AMERICANS WITH DISABILITY ACT (ADA) FACILITY ASSESSMENT REPORT

Americans with Disabilities Act (ADA) Facility Barrier Report

For Selected Park Sites

July 2024

Bella Vista Park

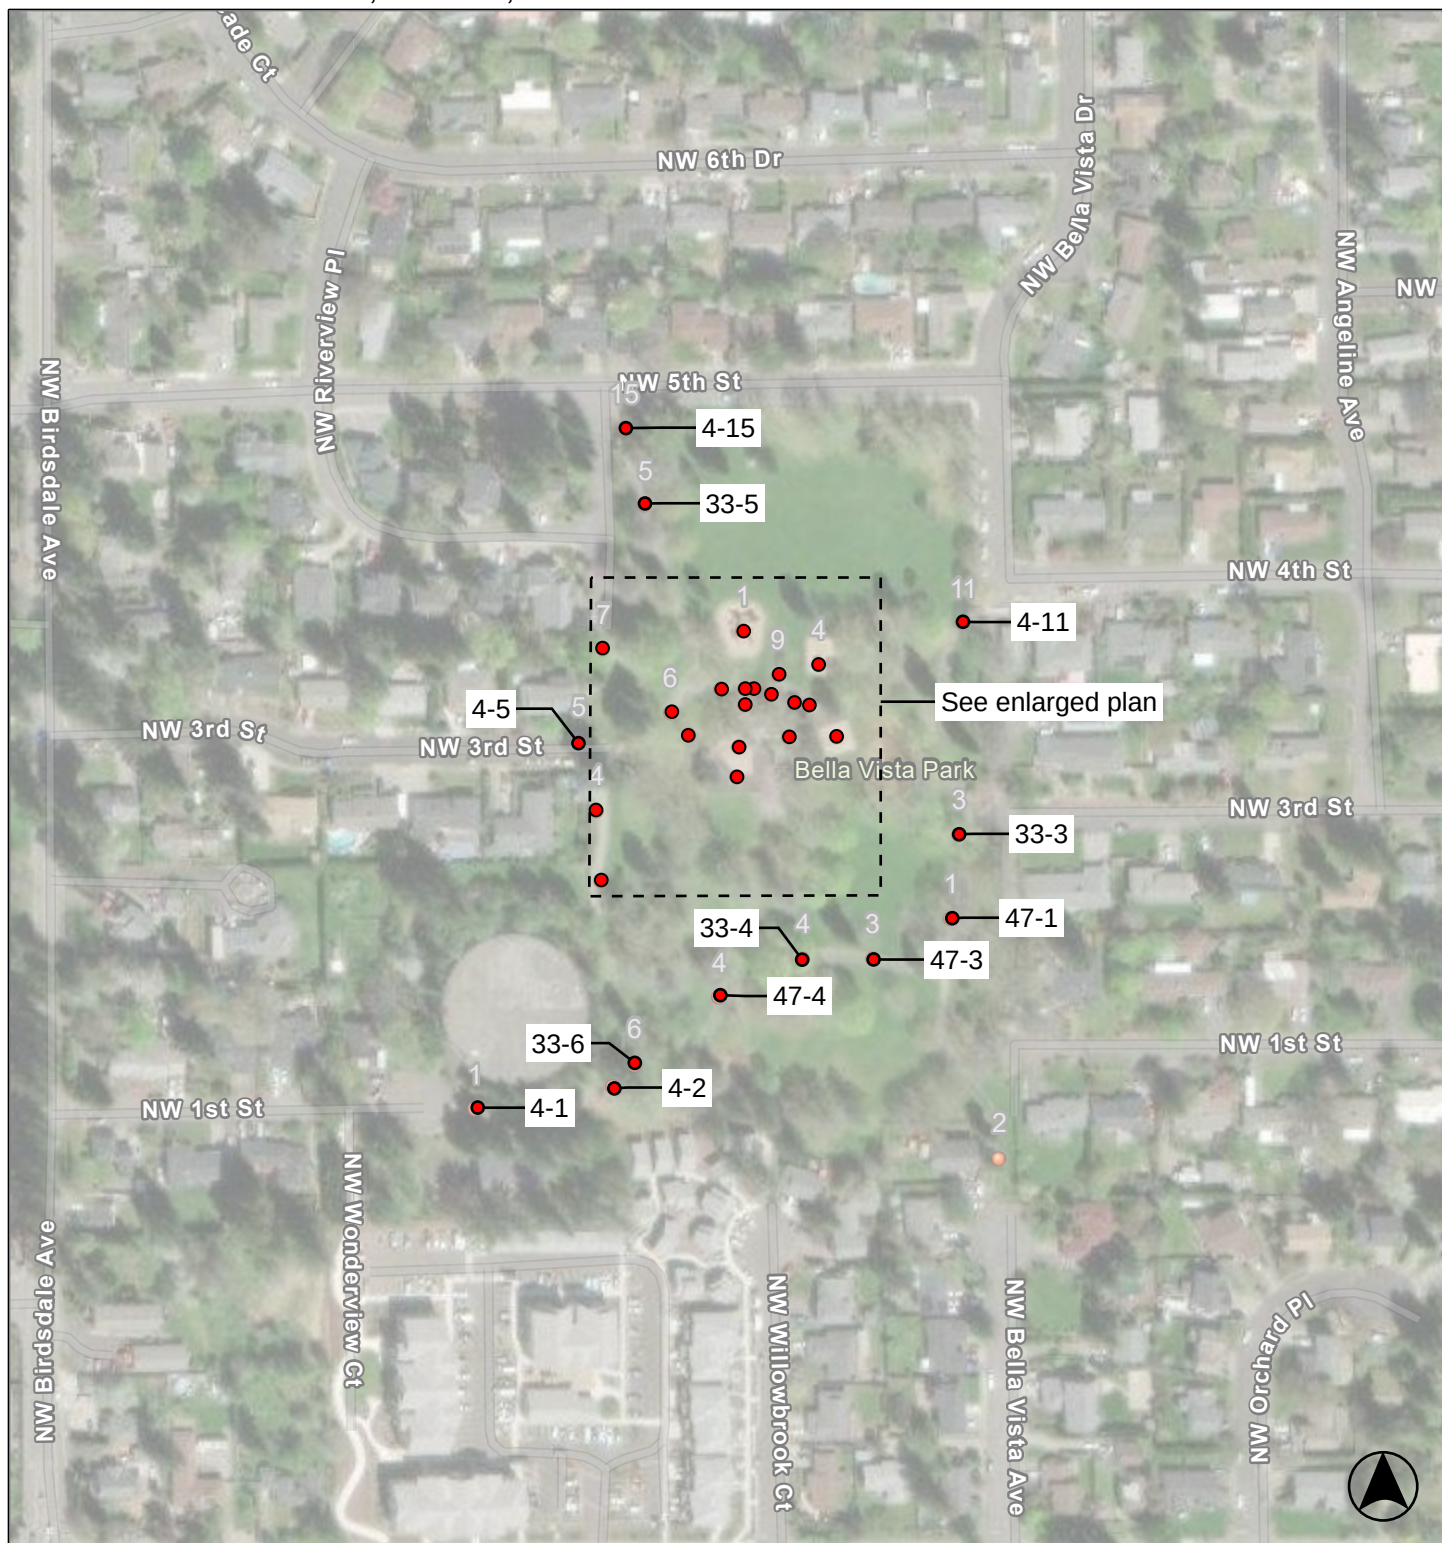
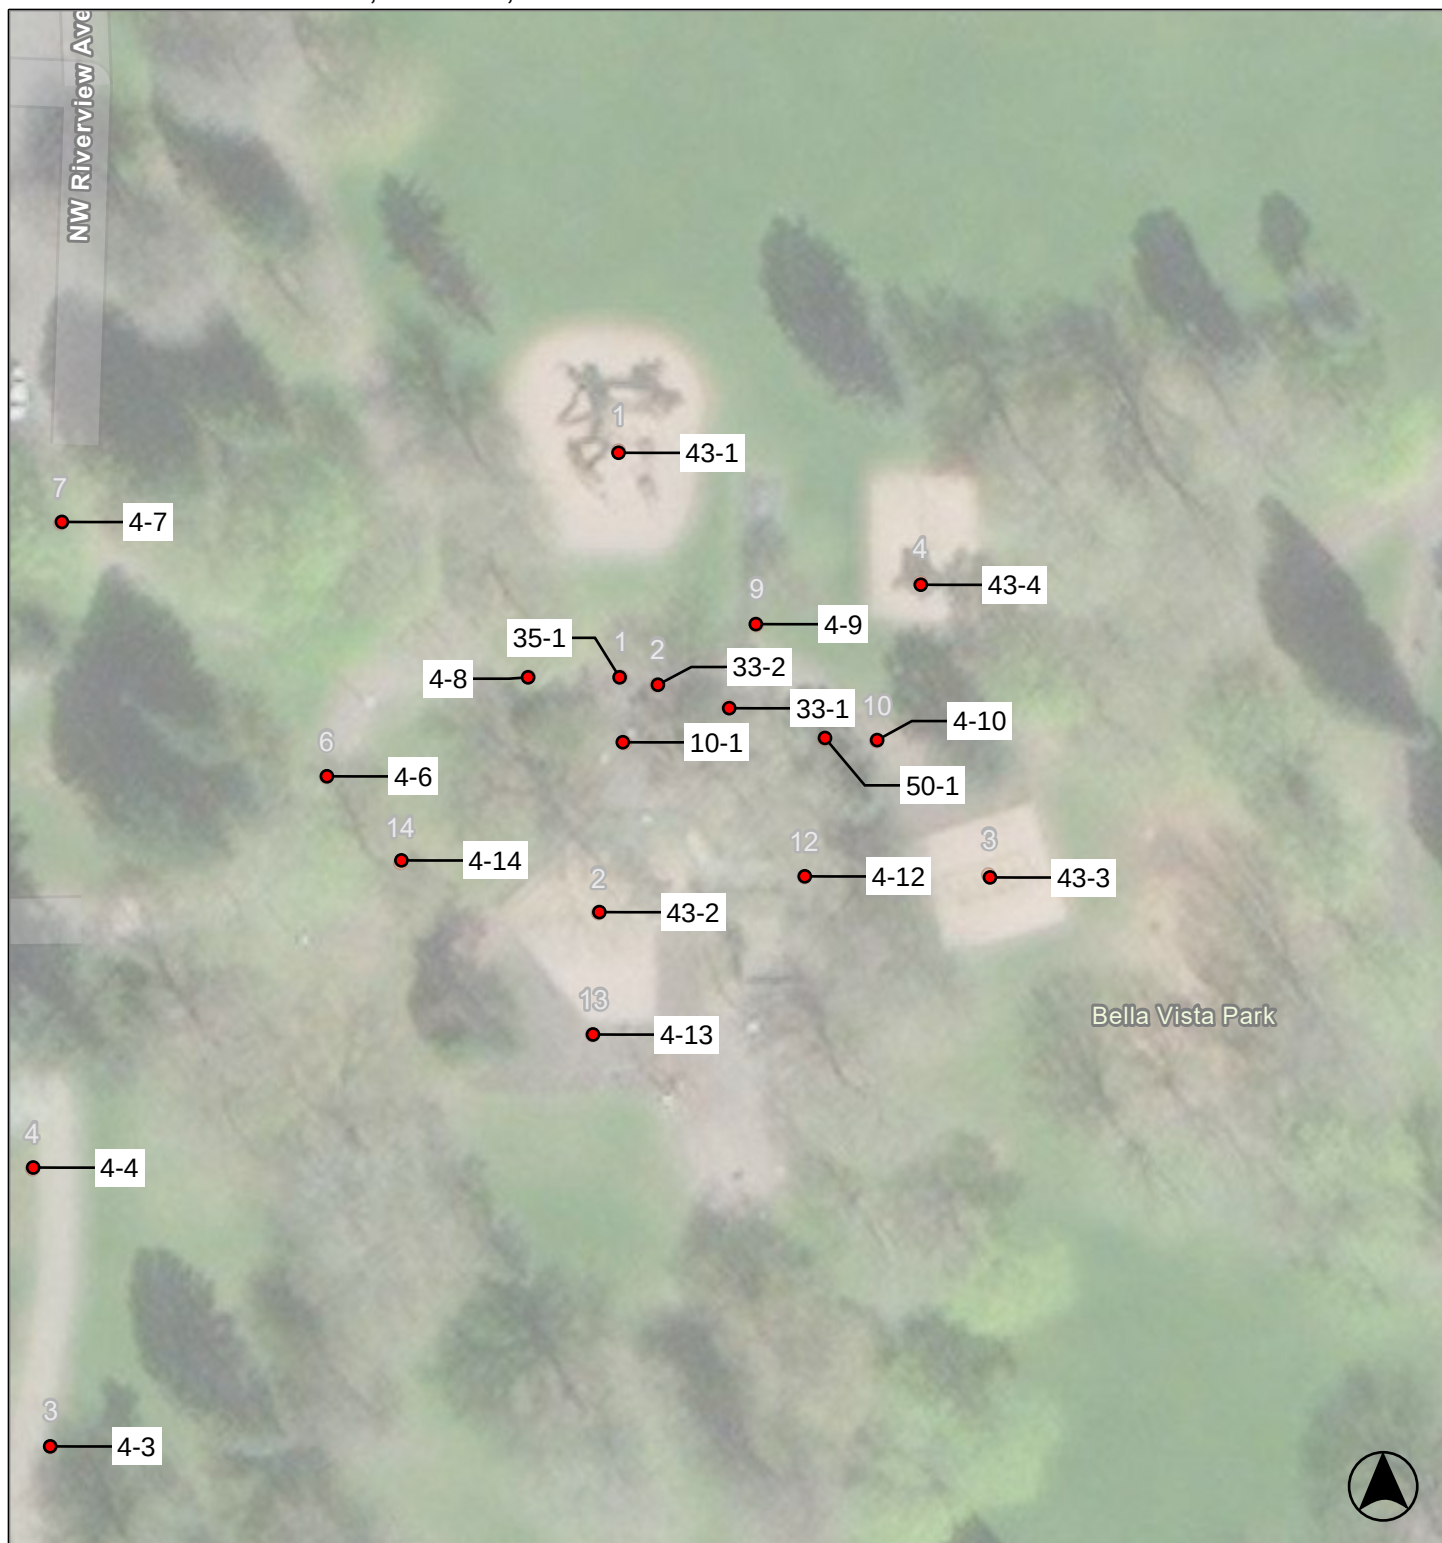
Park		
4 - 12	Walk	Category: 1
Regrade surface		\$4,700
Notes: Running slope of ramp near play area is up to 23.9% for 47 linear feet (5.0% max).		
ADA: 403.3		
Other: -		
Grind or patch vertical change of grade		\$100
Notes: Surface level change is greater than 1/2" due to crack (1/4" max; up to 1/2" with a 1:2 bevel).		
ADA: 303.2, 303.3		
Other: -		
4 - 13	Walk	Category: 1
Regrade surface		\$8,400
Notes: Cross slope of concrete around play area is up to 5.6% for 84 linear feet (2.0% max).		
ADA: 403.3		
Other: -		
Reduce or eliminate opening		\$300
Notes: Gap at crack in concrete is greater than 1/2" (1/2" max).		
ADA: 302.3		
Other: -		
4 - 14	Walk	Category: 1
Regrade surface		\$2,000
Notes: Cross slope of concrete is up to 6.0% for 20 linear feet (2.0% max).		
ADA: 403.3		
Other: -		
4 - 15	Walk	Category: 1
Regrade surface		\$6,600
Notes: Cross slope of concrete is up to 3.9%, run slope is up to 11.1% for 66 linear feet (2.0% max).

Park		
10 - 1	Drinking Fountain	Category: 3
Increase or provide maneuvering or clear floor area		\$1,270
Notes: There is a 2" vertical change in level at the clear floor space of the fountain (1/2" max).		
The clear floor space in front of the fountain is 17" wide (30" min).		
ADA: 305.1, 305.2, 305.3, 305.5, 306.1		
Other: -		
Confirm water flow compliance		\$0
Notes: Water service to the drinking fountain was disconnected at the time of the assessment. Flow height and angle could not be confirmed.		
ADA: 602.3, 602.6		
Other: -		
33 - 1	Outdoor Constructed Features	Category: 3
Increase or provide clear floor area		\$200
Notes: A clear ground space is not provided adjacent to the bench (36" by 48" min).		
ADA: -		
Other: ABA 1011.2.1, ABA 1011.2.3		
33 - 2	Outdoor Constructed Features	Category: 3
Regrade surface		\$20
Notes: Clear ground space adjacent to the trash container has a slope of 7.5% (2.0% max).

ADA: 305.1		
Other: ABA 1011.2.3		
33 - 3	Outdoor Constructed Features	Category: 3
Increase or provide clear floor area		\$200
Notes: A clear ground space is not provided adjacent to the bench (36" by 48" min).		
ADA: -		
Other: ABA 1011.2.1, ABA 1011.2.3		
33 - 4	Outdoor Constructed Features	Category: 3
Increase or provide clear floor area		\$200
Notes: A clear ground space is not provided adjacent to the bench (36" by 48" min).		
ADA: -		
Other: ABA 1011.2.1, ABA 1011.2.3		
33 - 5	Outdoor Constructed Features	Category: 3
Increase or provide clear floor area		\$200
Notes: A clear ground space is not provided adjacent to the bench (36" by 48" min).		
ADA: -		
Other: ABA 1011.2.1, ABA 1011.2.3

Park		
33 - 6	Outdoor Constructed Features	Category: 3
Increase or provide clear floor area		\$200
Notes: A clear ground space is not provided adjacent to the bench (36" by 48" min).		
ADA: -		
Other: ABA 1011.2.1, ABA 1011.2.3		
35 - 1	Other	Category: 3
Reposition controls		\$285
Notes: Operating mechanism of dog bag station is 60" above the ground (15" min to 48" max).		
ADA: 308.2, 308.2.1		
Other: -		
43 - 1	Play Equipment Area	Category: 2
Improve or evaluate play area surface		\$0
Notes: Ground surface in play area is in need of maintenance and further evaluation of fall attenuation surface is recommended.		
ADA: 1008.2.6.1, 1008.2.6.2		
Other: -		
43 - 2	Play Equipment Area	Category: 2
Improve or evaluate play area surface		\$0
Notes: Ground surface in play area is in need of maintenance and further evaluation of fall attenuation surface is recommended.		
No accesible route to the slide landing.		
ADA: 1008.2.6.1, 1008.2.6.2

Other: -		
43 - 3	Play Equipment Area	Category: 2
Improve or evaluate play area surface		\$0
Notes: Ground surface in play area is in need of maintenance and further evaluation of fall attenuation surface is recommended.		
ADA: 1008.2.6.1, 1008.2.6.2		
Other: -		
Regrade or replace ramp		\$540
Notes: The ramp into the play area has a 10.3% slope (8.33% max).		
ADA: 240.2.1		
Other: -

Park		
43 - 4	Play Equipment Area	Category: 2
Improve or evaluate play area surface		\$0
Notes: Not surveyed due to closure.		
ADA: 1008.2.6.1, 1008.2.6.2		
Other: -		
47 - 1	Trails	Category: 2
Install sign		\$250
Notes: A trail sign is not provided.		
ADA: -		
Other: ABA 1017.10		
Provide resting interval in path of travel		\$2,540
Notes: A resting interval is required at 30 feet.		
ADA: -		
Other: ABA 1017.4		
Regrade surface		\$4,200
Notes: Trail slope is between 8.3 - 10% for 70 feet (2% max. for concrete, asphalt or boards or 5% max. for all other surfaces).		
ADA: -		
Other: ABA 1017.7.2		
47 - 2	Trails	Category: 2
Regrade surface		\$2,400
Notes: Running slope of trail is up to 13% for 40 linear feet (10 feet max when running slope between 10% and 12.5%).		
ADA: -		
Other: ABA 1017.7.1		
47 - 3	Trails	Category: 2
Regrade surface		\$4,140
Notes: Up to 5% cross slope for 69 feet (2% max. for concrete, asphalt or boards or 5% max. for other surfaces).

Park		
47 - 4	Trails	Category: 2
Regrade surface		\$5,340
Notes: Up to 8% cross slope for 89 feet (2% max. for concrete, asphalt or boards or 5% max. for other surfaces).		
ADA: -		
Other: ABA 1017.7.2		
Regrade surface		\$11,100
Notes: Up to 6% cross slope for 185 feet (2% max. for concrete, asphalt or boards or 5% max. for other surfaces).		
ADA: -		
Other: ABA 1017.7.2		
Regrade surface		\$600
Notes: Running slope of trail is up to 12% for 10 linear feet (30 feet max when running slope between 8.33% and 10%).		
ADA: -		
Other: ABA 1017.7.1		
50 - 1	Universal Design Recommendations	Category: 5
Increase or provide clear space		\$0
Notes: Provide a clear floor space for approach to the informational sign. Consider providing a larger text size, tactile information, and/or audio options for visitors with visual disabilities.		
ADA: -		
Other: -

Hall Park

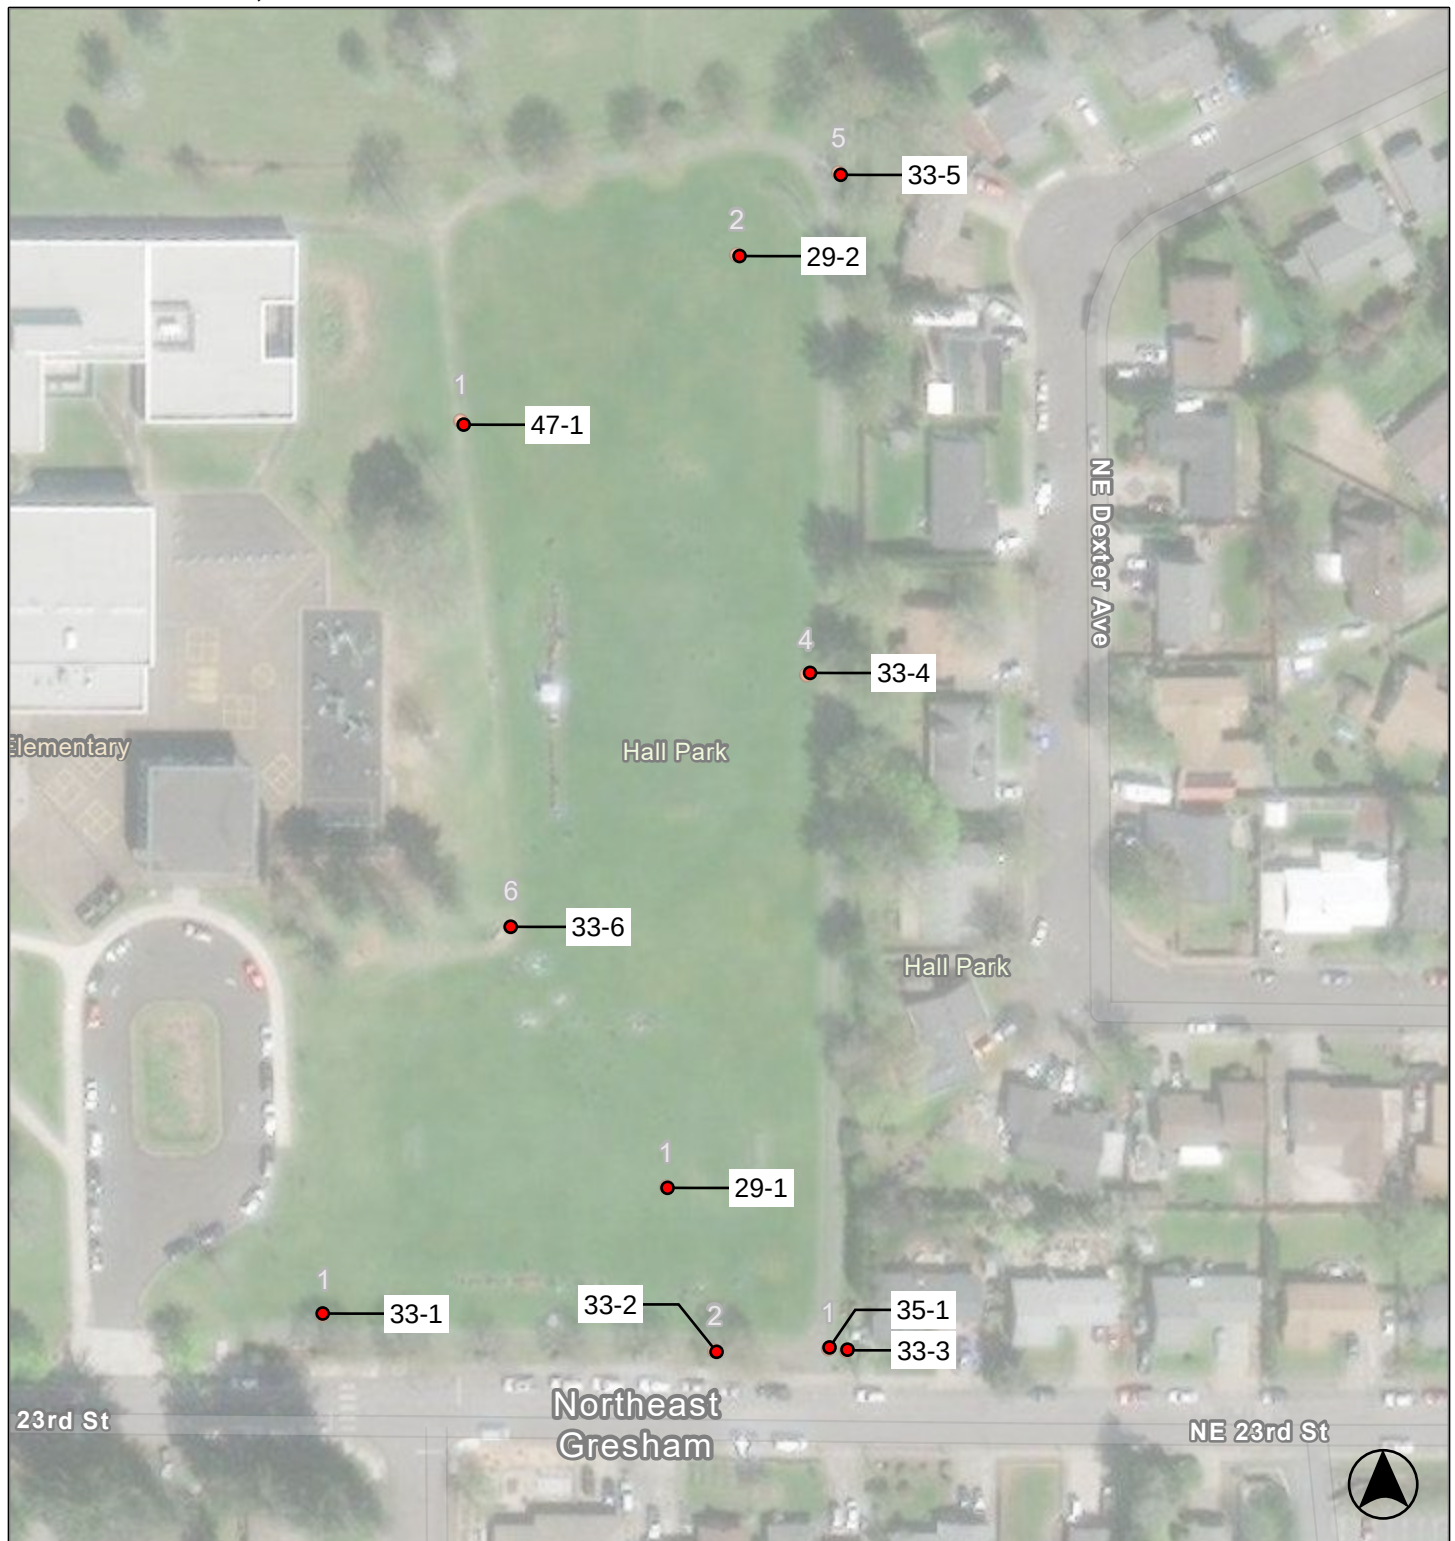
Park		
29 - 1	Game and Sports Area	Category: 2
Provide an accessible route		\$7,600
Notes: An accessible route to the soccer field is not provided. Route from entry to the field is 96 linear feet over grass and gravel.		
ADA: 206.2.2		
Other: -		
29 - 2	Game and Sports Area	Category: 2
Provide an accessible route		\$49,040
Notes: An accessible route to the backstop is not provided. Route from the soccer field is 613 linear feet over grass and gravel.		
ADA: 206.2.2		
Other: -		
33 - 1	Outdoor Constructed Features	Category: 3
Increase or provide clear floor area		\$200
Notes: A clear ground space is not provided adjacent to the bench (36" by 48" min).		
ADA: -		
Other: ABA 1011.2.1, ABA 1011.2.3		
33 - 2	Outdoor Constructed Features	Category: 3
Increase or provide clear floor area		\$200
Notes: A clear ground space is not provided adjacent to the bench (36" by 48" min).		
ADA: -		
Other: ABA 1011.2.1, ABA 1011.2.3

33 - 3	Outdoor Constructed Features	Category: 3
Increase or provide clear floor area		\$200
Notes: A clear ground space is not provided adjacent to the bench (36" by 48" min).		
ADA: -		
Other: ABA 1011.2.1, ABA 1011.2.3		
33 - 4	Outdoor Constructed Features	Category: 3
Increase or provide clear floor area		\$200
Notes: A clear ground space is not provided adjacent to the bench (36" by 48" min).		
ADA: -		
Other: ABA 1011.2.1, ABA 1011.2.3		
33 - 5	Outdoor Constructed Features	Category: 3
Increase or provide clear floor area		\$200
Notes: A clear ground space is not provided adjacent to the bench (36" by 48" min).		
ADA: -		
Other: ABA 1011.2.1, ABA 1011.2.3

Park		
33 - 6	Outdoor Constructed Features	Category: 3
Increase or provide clear floor area		\$200
Notes: A clear ground space is not provided adjacent to the bench (36" by 48" min).		
ADA: -		
Other: ABA 1011.2.1, ABA 1011.2.3		
47 - 1	Trails	Category: 2
Provide a firm, stable and slip resistant surface		\$52,400
Notes: The trail surface is not firm and stable. Trail surface is dirt, gravel, and grass for 1310 linear feet around the park, from baseball to the entrance.		
ADA: -		
Other: ABA 1017.2
